**RECONSTRUCTION OF  
US-231  
BETWEEN BOWLING GREEN  
AND SCOTTSVILLE, KY**

Project Item No.  
3-146.00

**VALUE ENGINEERING STUDY  
FINAL REPORT**

March 26, 1997

## SKETCH OF RECOMMENDED DESIGN

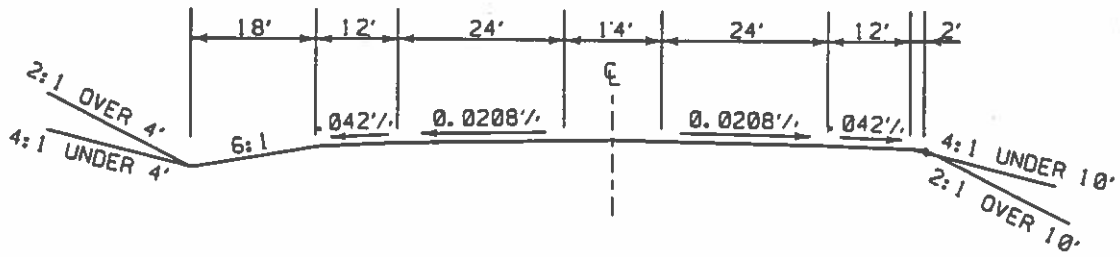
DESCRIPTIVE TITLE OF RECOMMENDATION: From Dye Ford Road to South of Drakes Creek Bridge, the roadway section will be an urban 5-lane section with shoulders.

## RECOMMENDED CHANGE:

It is recommended that a new 5-lane urban roadway section with shoulders will connect to the presently designed 5-lane urban roadway with curb and gutters at Dye Ford Road and extend to the south for approximately 2.6 kilometers (1.6 miles). The 5-lane urban section north of Dye Ford Road includes curb and gutter, sidewalk and storm drain collect system. The recommended new 5-lane urban section continuing south from Dye Ford Road will include 12-foot wide outside shoulders in lieu of curb and gutter. The new section will extend from Dye Ford Road to station 14 + 200 (approximately) 200 meters south of Duke's Bridge.

IDENTIFICATION NUMBER: B-4A

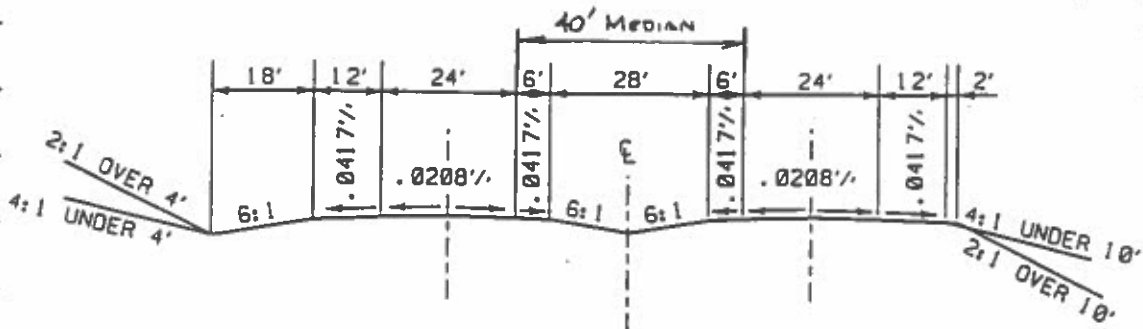
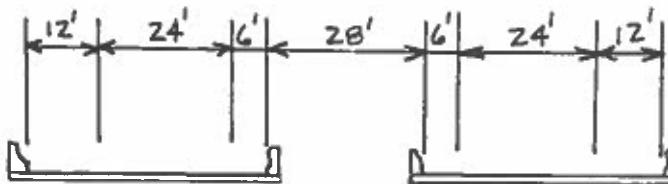
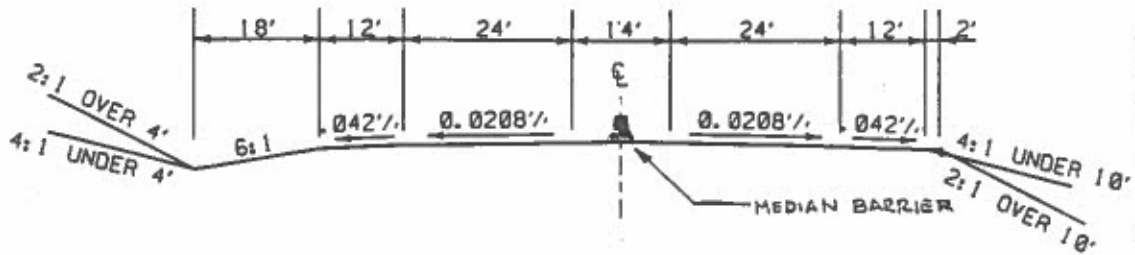
DESCRIPTIVE TITLE OF RECOMMENDATION: From Dye Ford Road to South of Drake's Creek Bridge, the roadway section will be an urban 5-lane section with shoulders. Option A includes median Barrier.

## RECOMMENDED CHANGE:

The roadway section will include two 3.3 meter driving lanes and a 3.3 meter outside shoulders in each direction. The new roadway segment will have a 1200-foot minimum between access points. A paved median will be 4.2 meters (14 feet) wide. A median Jersey barrier will be placed in the center of the 4.2 meter median. The new roadway section will extend across the Drake's Creek flood plain requiring two 26-meter (84-foot) wide bridges, (one bridge over Drake's Creek and one over Drake's Creek backwater area) in lieu of the 4 bridges required in the original design. **Recommendation B-4A is the same as B-4 with the addition of a median barrier.**

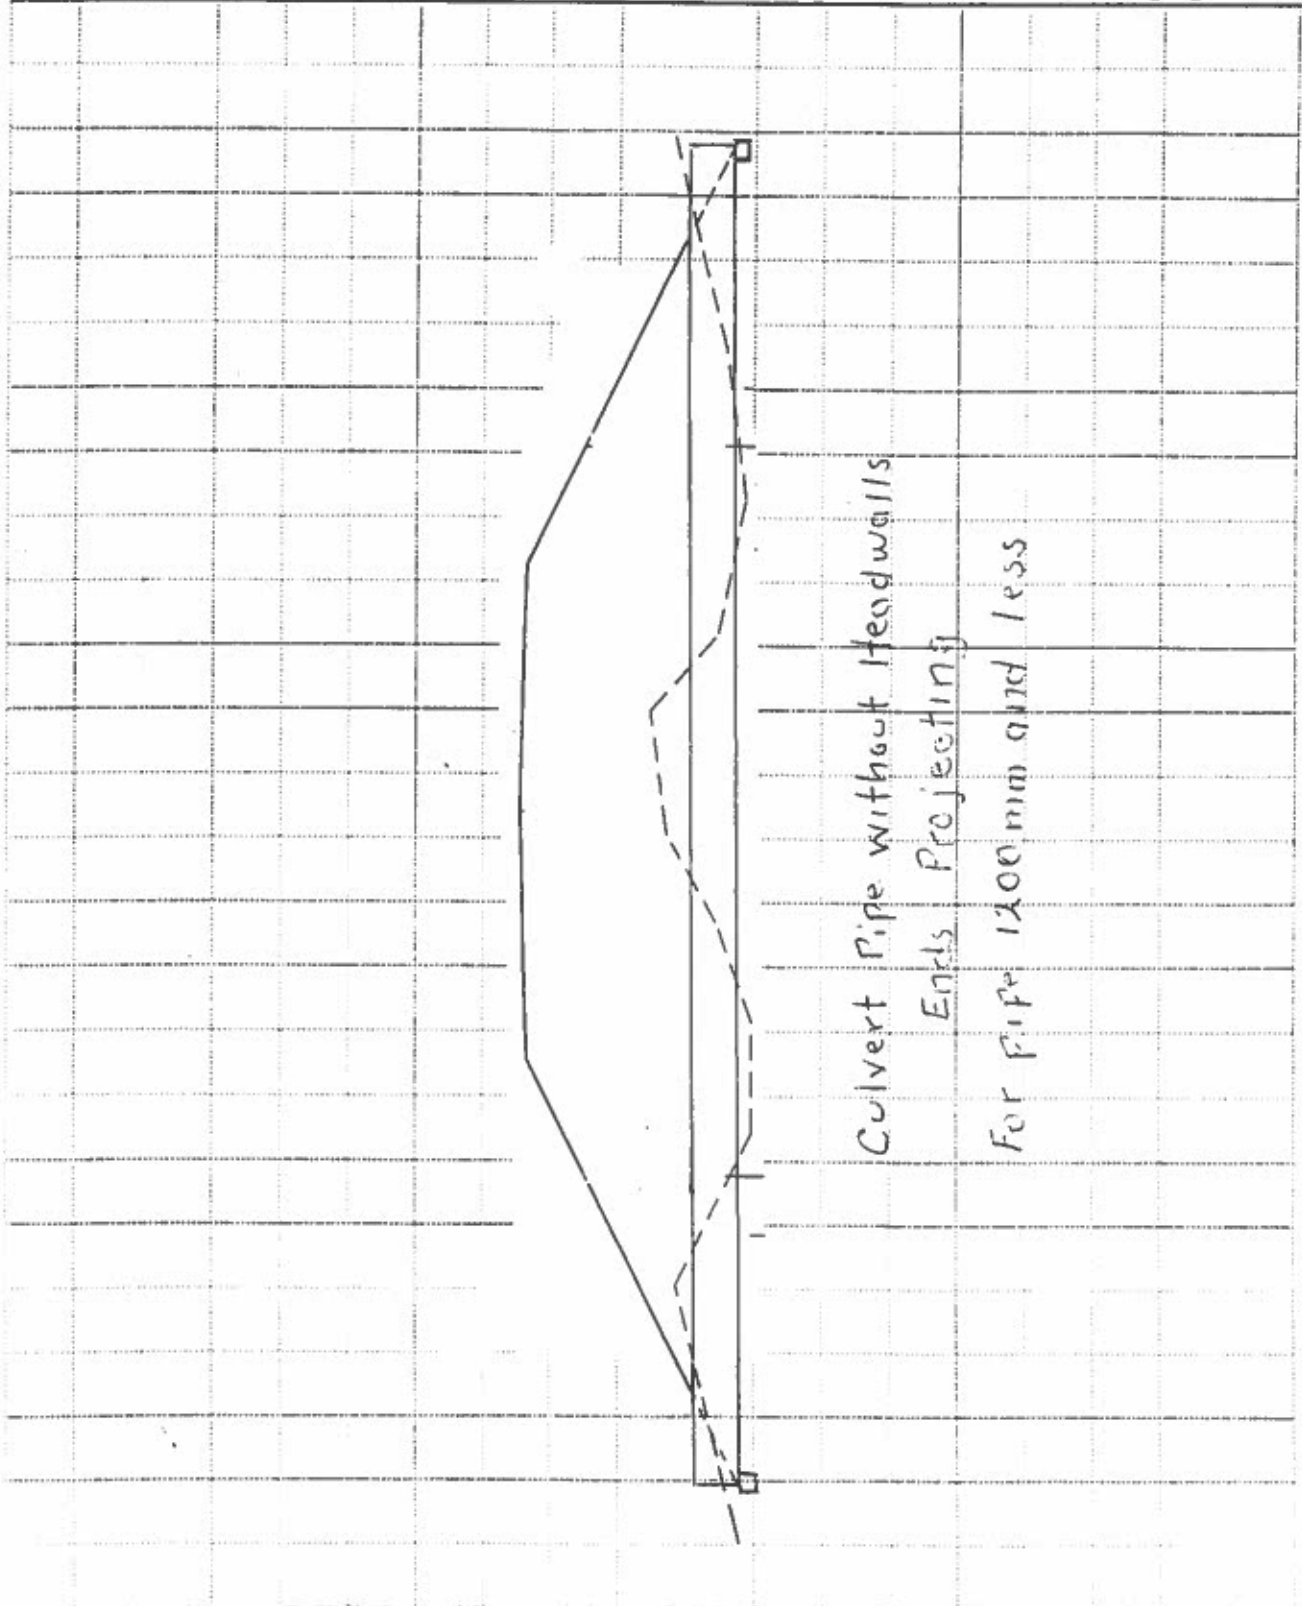
- Other states are currently using this detail with apparent success.
  - Damage by out-of-control vehicles should be rare because this detail will only be used outside the clear zone. Inside the clear zone the detail will continue to be a head wall.
-

- Damage by mowers will be slight, if any, because the pipes will, as a hole, be located in areas where mowing is not done.
- This job is a good one to try this detail on because US-231 is a ridge road design having few cross drains compared to other roads. This would mean that this recommendation could be tried on this project with less risk. If it does not work - it can be reversed later by installation of head walls.

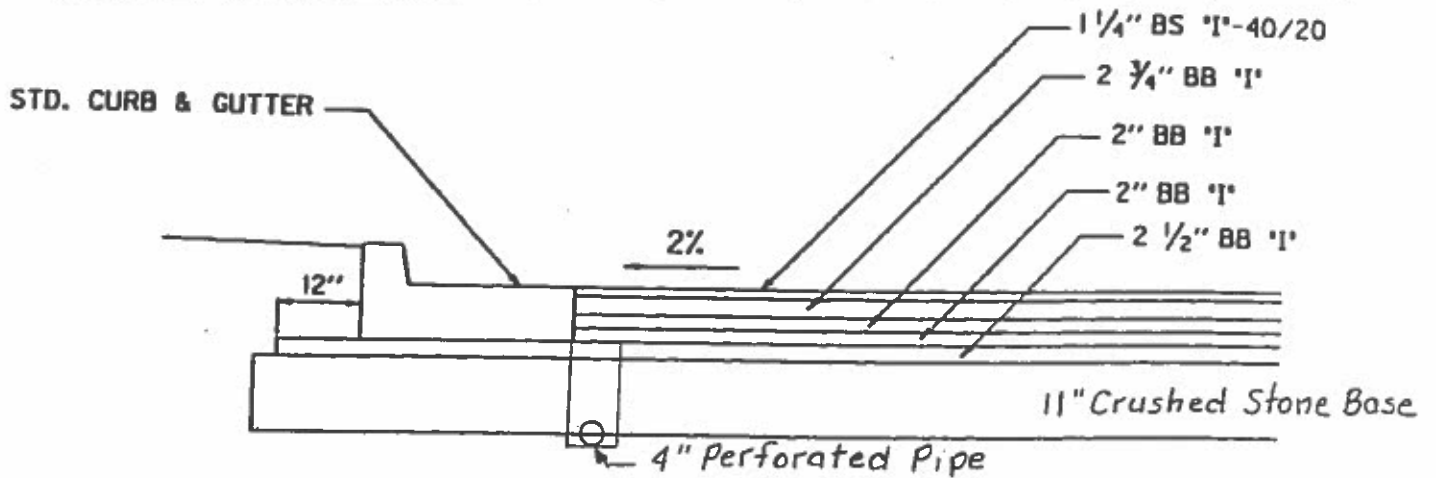
DESCRIPTIVE TITLE OF RECOMMENDATION: Add perforated pipe in curb and gutter section for drainage purposes.

Curb and gutter with bituminous pavement underlain by a crushed stone base. Perforated pipe added at gutter lines to drain pavement.

- Providing positive drainage for the subbase will increase the life of the pavement and decrease the amount of rutting. Rutting is occurring in the existing urban section that
- connects to this project. By reducing the rutting, maintenance costs will be reduced and there will be less disruption to the traveling public.

STANDARD DRAWING NO. RGX-002-06

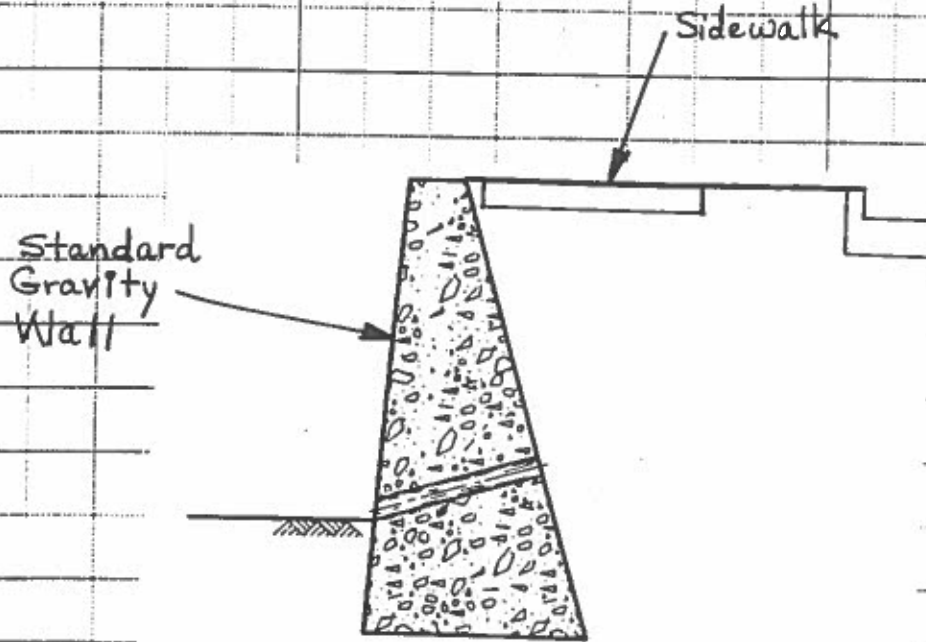
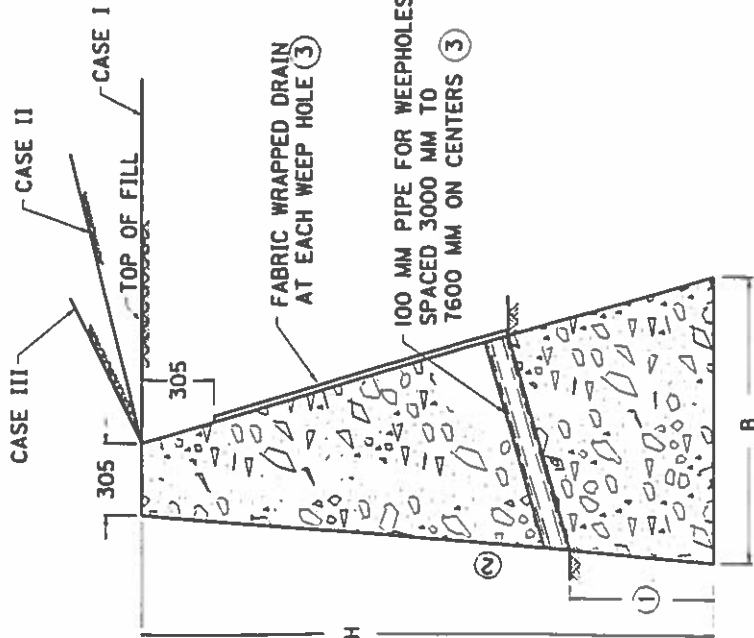
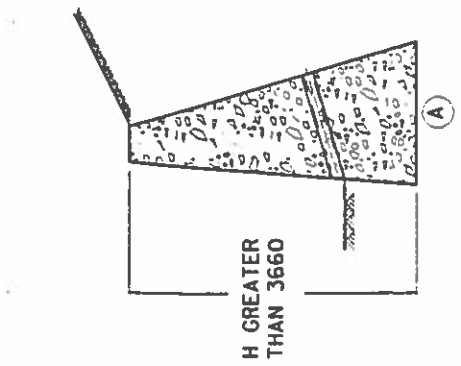
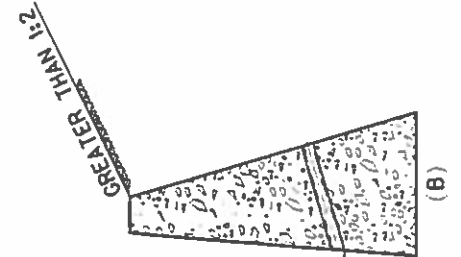
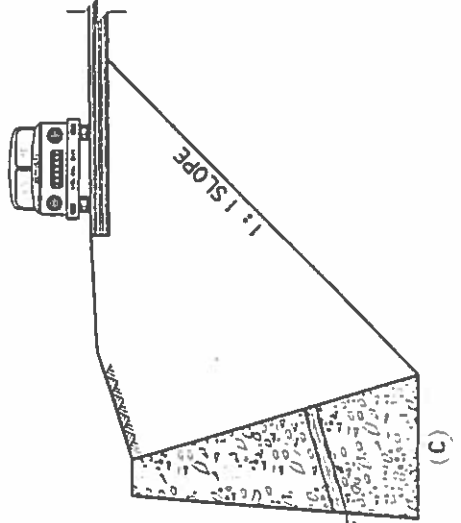
- Modular block walls are more attractive and can be provided in a variety of colors and styles.
- Modular block walls are flexible and can withstand movements and settlements.
- Modular block walls are easier and quicker to construct. The impact on the parking lot would be less than that of the form work and curing times associated with the standard gravity wall.
